5344948

**ON-SITE SEWAGE DISPOSAL SYSTEM  
HOWARD COUNTY HEALTH DEPARTMENT  
BUREAU OF ENVIRONMENTAL HEALTH**

SUBDIVISION: Heritage Heights LOT NUMBER: 11

ADDRESS: 6118 Thompson Dr. PROPERTY OWNER: David Szeliga

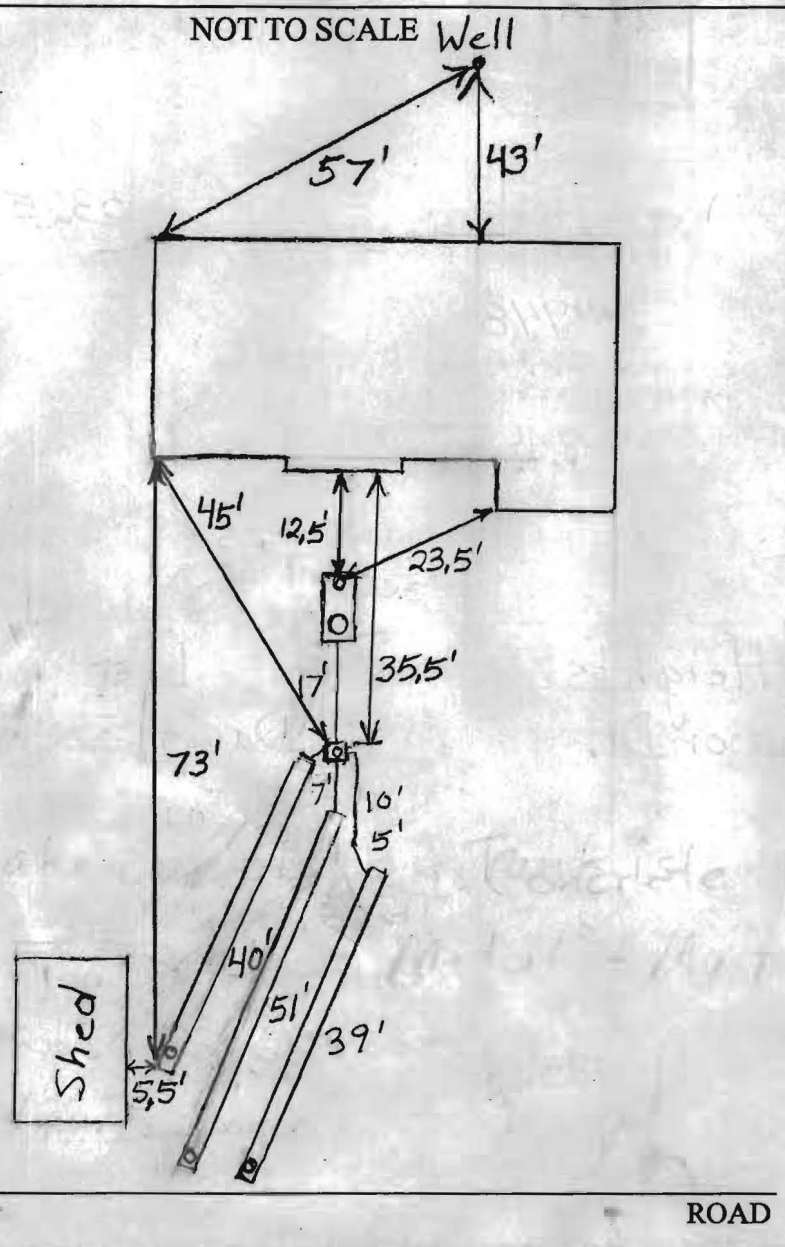
TRENCHES:	Trench to be feet wide. Inlet feet below original grade. Bottom maximum depth feet below original grade. Effective area begins at feet below original grade. feet of stone below distribution pipe.
LOCATION:	Install 3 Trenches on Contour Toward Shed Area Between Existing Trench and Shed
NOTES:	Well at 6112 Thompson Dr. is Buried Must Get Location Before Installing Trenches

PRE-CONSTRUCTION 3/11/2010 Cannot locate well of downhill neighbor's house. No one home to provide information.

INSTALLATION Must locate before installation. System working at this time. Public sewer may be available in the future (PB) 4/11/2013 Layout redone with Foggles. Public sewer still not available. May want to apply for pretreatment money. Soil is bad for septic systems.

4/15/13 - At site for inspection and contractor was no show - pk. to Foggles office, stated they would call it back (PB)

4/19/2013 System finished. O.K. to backfill. (PB)
